ATTACHMENTS

Conceptual Site Model Topics

Comments on TUA Deliverables Red Hill Bulk Fuel Storage Are Oahu, Hawaii

August 14, 2018

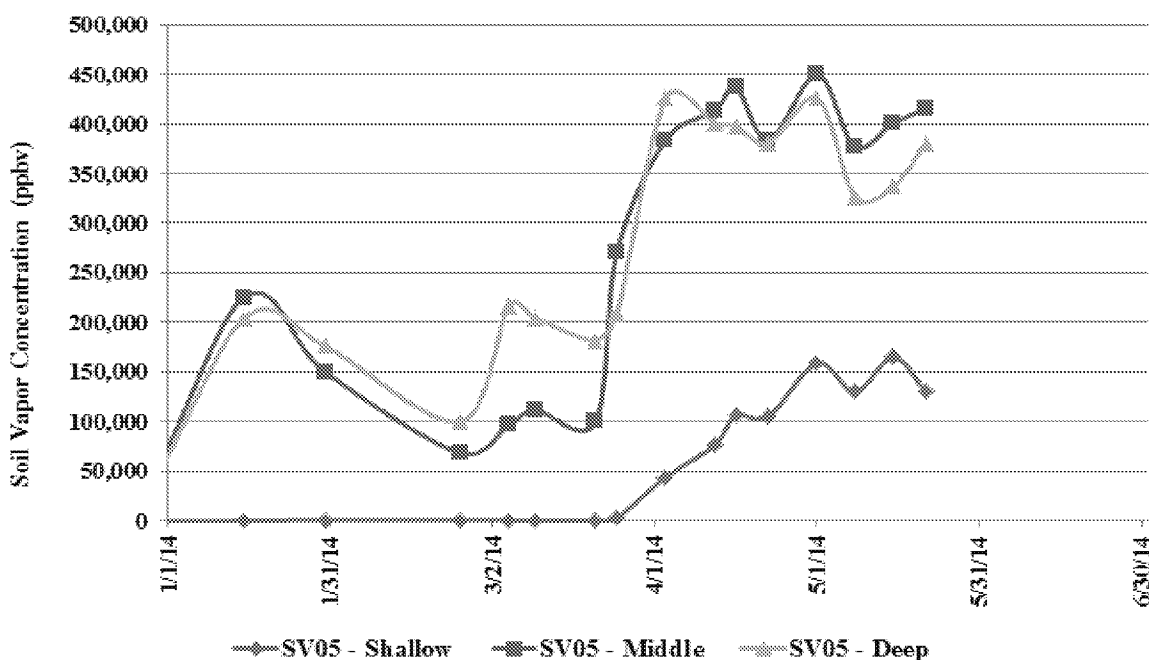
The in situ vapor probe response around Tank 5 in the timeframe following the 2014 release suggests that the primary LNAPL migration was to the northwest side of that tank and not in the direction of

RHMW02 (see Figure X.3 below). Actual transport outcomes beneath Tank 5 in 2014 below the vapor probes is unknown; the conservative assumption based on this limited data is that transport was potentially to the northwest and is not represented with any certainty by the spatially limited monitoring well array.

In terms of the depth of migration of LNAPL from the Tank 5 release in 2014, the primary analysis relied upon in the CSM is the thermal profile at RHMW02, with backup support from chemistry considerations. A net positive temperature profile indicates the effects of exothermic biologic reactions and is affected by a variety of subsurface factors. In general, that relationship can be useful to infer lateral distributions of LNAPL biodegradation (e.g., Figure X.2 above) but is highly uncertain with respect to the LNAPL vertical distribution. In many cases, as shown in the example thermal profile in our August 15, 2018 presentation (Slide 28), the LNAPL vertical mass distribution cannot be inferred from the temperature profile. We believe the Navy technical team needs to validate its interpretation of LNAPL transport around Tank 5 from the 2014 release, as it is a fundamental cornerstone to the remainder of the LNAPL F&T considerations. At a minimum, this would include several Hawai'i or equivalent case examples where the LNAPL source distribution has been definitively interpreted by this method and independently validated through subsurface data demonstrating that actual LNAPL source distribution (e.g., soil cores, LIF investigation, etc.). Alternatively and preferred would be a site specific data collection program to verify the LNAPL source distribution around Tank 5 and possibly other key locations. If that were to be initiated, those first borings should be located to the northwest of Tank 5 where vapor data suggest the potential direction of LNAPL migration occurred.

Figure 10.4 Observed naphthalene concentrations following the 2014 Tank 5 release and a family of conceptual contaminant transport breakthrough curves matching those data. Other interpretations are viable, as is the possibility of LNAPL contacting groundwater near RHMW02 following that release.

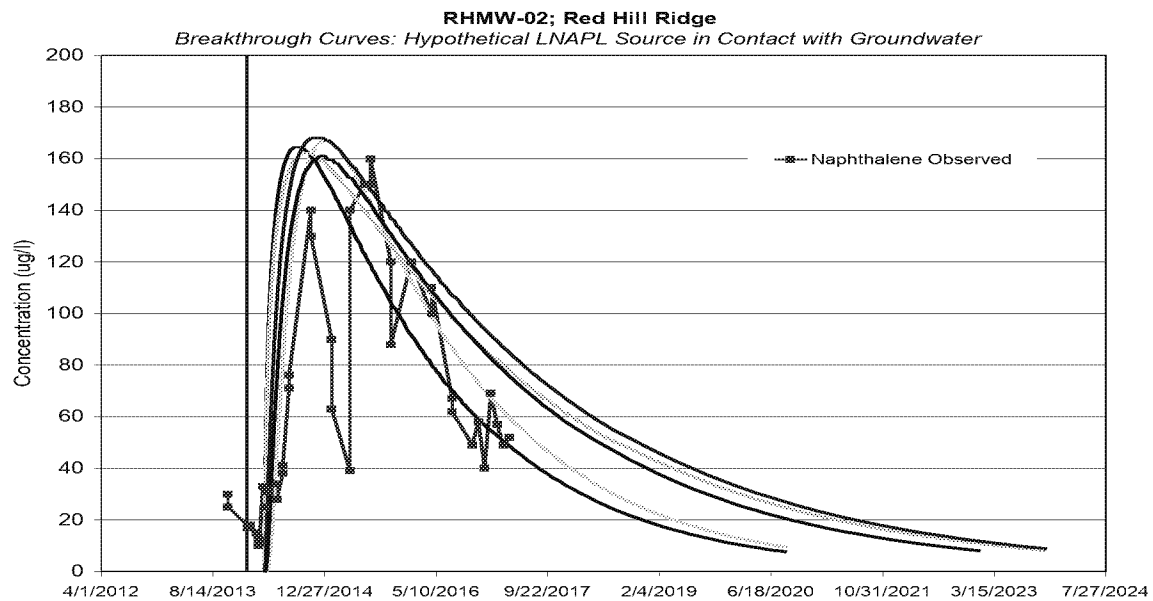
Lastly, CoC concentrations in groundwater at RHMW02 (and occasionally other locations) have often been within the expected solubility ranges for jet, diesel and other fuels stored at the facility, suggesting that LNAPL is likely in direct contact with the aquifer system somewhere in the vicinity. Robert Whittier of the DOH has visually observed LNAPL sheens at RHMW02 in the past, consistent with the solubility range concentrations. In particular, there was a distinct increase in several CoCs at this location immediately following the 2014 release that can be interpreted as a breakthrough curve (Figure X.4). While the Navy team's interpretation is of simple coincident data scatter, these data could also conservatively be interpreted as a new arrival of LNAPL to groundwater in the general vicinity of that well in the timeframe associated with that release. This alternate interpretation of LNAPL reaching the groundwater table following the 2014 release is consistent with site data and transport processes. The CSM would benefit by including this potential as one of the viable working hypotheses, as it is certainly the conservative assumption within this spatially sparse data set. The chemical analyte ratio methods used to suggest otherwise in the CSM are unbounded by site specific data of fuel compositional variability and analyte transformations. Further, we believe where chemical ratios use TPHd values, those should be the native totals and not the silica gel cleaned results because the parent hydrocarbons are predominantly derived from the original petroleum source(s) (whether polar or not as daughter products).

2. Saprolite Extents

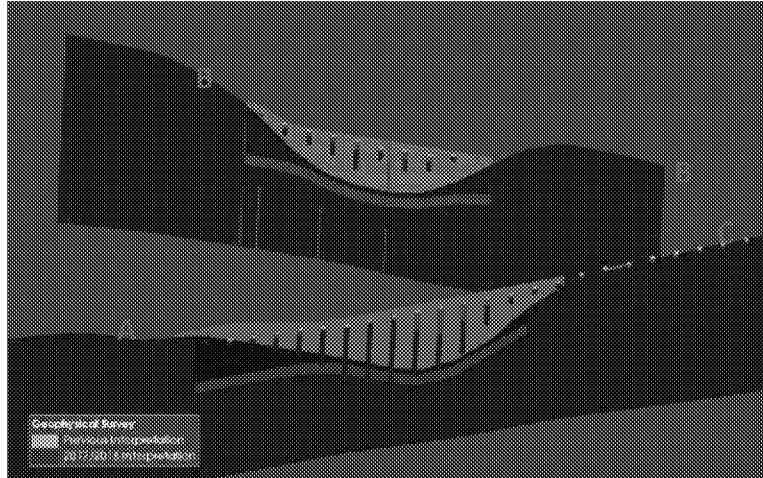
- Valley alluvium thickness
- Systematic pattern of modeled saprolite depth
- Early termination of longitudinal extents of saprolite
- Layer elevations based on prior interpretations may require revision to accurately represent conditions

Figure 5-9 CSM

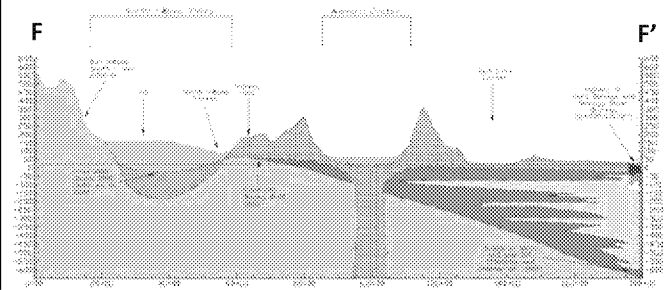
- Model appears to lack the confining nature of older alluvium.
- Expect bulk hydraulic conductivity of the caprock to be $\ll 1,000$ ft/d

5. Tunnel Inflows

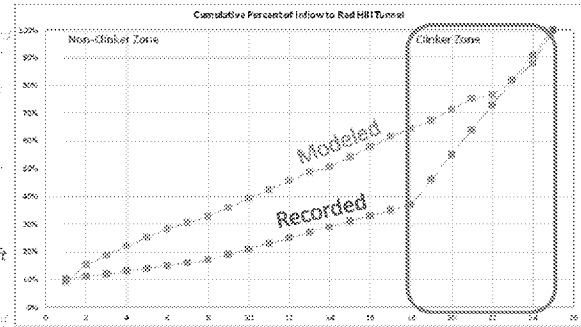
"The heterogeneous nature of the clinker is revealed in the geologic log at the Red Hill Shaft-water development tunnel prepared by the USGS (Stearns, 1943). That log, reproduced as Figure 5-10, reveals that water inflows were measured by the USGS as the tunnel was being constructed. The log shows that flow rates dramatically increased as the tunnel penetrated beyond 550 ft, which is attributable to a large increase in permeability at the basal location, the Figure 5-10, and relatively thin 'clinker' logged in the first 150 ft of the tunnel's water lift produced essentially no groundwater. The tunnel was described as 'dry' during tunneling out to about 480 ft from the shaft. Subsequent thinning of this section, but often even sand pits, produced about 1.5 mgd. Progressing beyond 480 ft, the tunnel produced greater water inflows. At 700 ft the rate was estimated to be 5 mgd. After working 180 ft, the flow rate had risen to 12 mgd. From that point forward, the rate of inflow increased as the tunnel progressed much faster. In the last 200 ft of the tunnel, 980–1,180 ft from the shaft, the groundwater inflows increased from 12 mgd to 29 mgd. The thicker clinker zone shown on the geologic log (Stearns 1943) produced the majority of the groundwater. This 200-ft clinker produced about 8 times more water than the clinker and pāhoehoe logged in the initial 480 ft of the tunnel. In summary, by the end of the Red Hill water development tunneling project, the groundwater inflow from the tunnel had increased from approximately 5 mgd to 29 mgd in the last 500 ft of

6. Calibration – Heads, Gradients

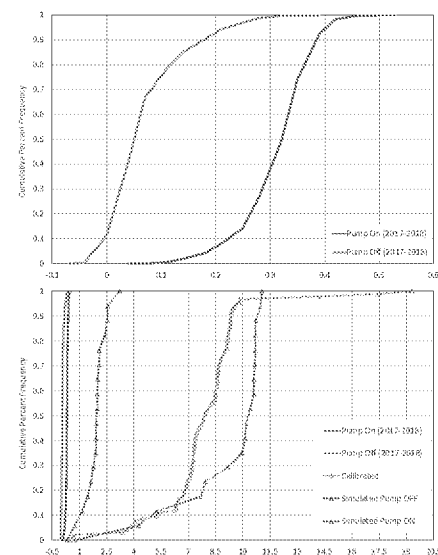
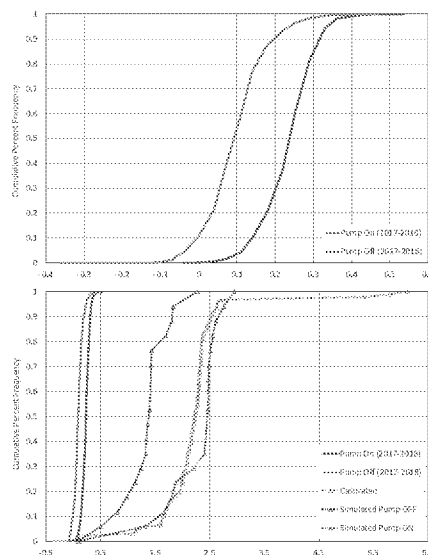
- Historic manual data infrequent, irregular
- Synoptic data improve CSM
 - Time-weighting
- Absolute head vs. gradients
- Systematic difference

7. LNAPL F&T - Vapor Data

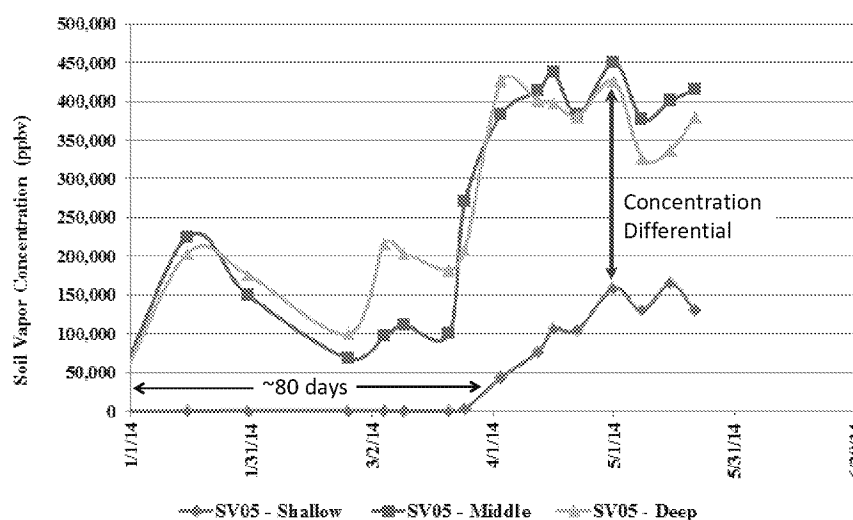
- RHMW05 vapor behavior following 2014 release
- Shallow (interior) port slowest to respond, and response damped

9. Groundwater Data

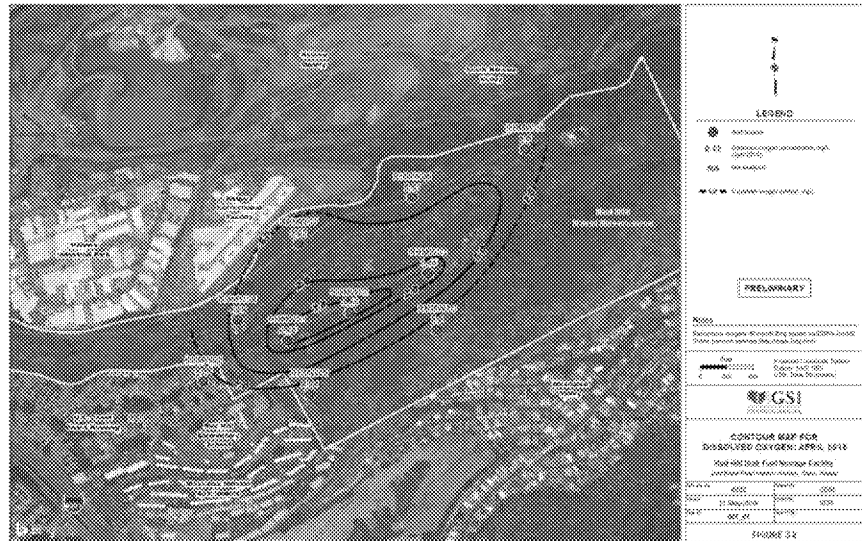
Distal
detections
at of TPH
(even
recognizing
some data
should be
qualified)

Figure 3-2: Contour Plot of O_2 Concentrations from the Facility Groundwater Monitoring Network (April 23-25, 2018)

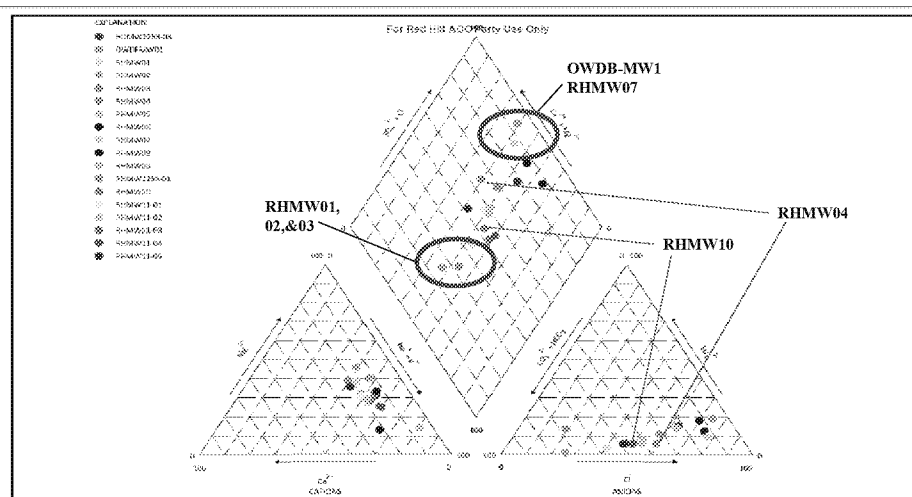
- Natural attenuation parameters describe a plume shadow:
- Example shown is depleted O_2

9. Groundwater Data

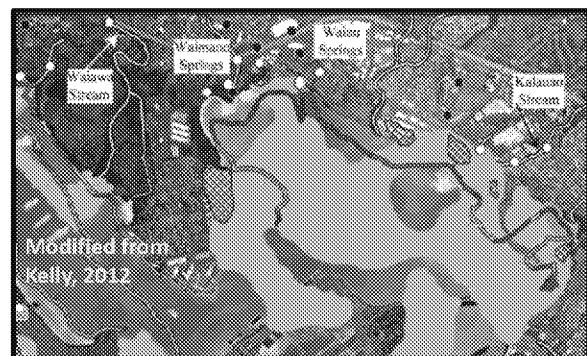
Chemistry shows indication of a poorly mixed system

- Chloride conc. vary from ~40- >1000 mg/L
- Southeast very different from northwest
- Northwest chlorides still highly variable
- A large flux of groundwater down the Red Hill ridge should show better mixing
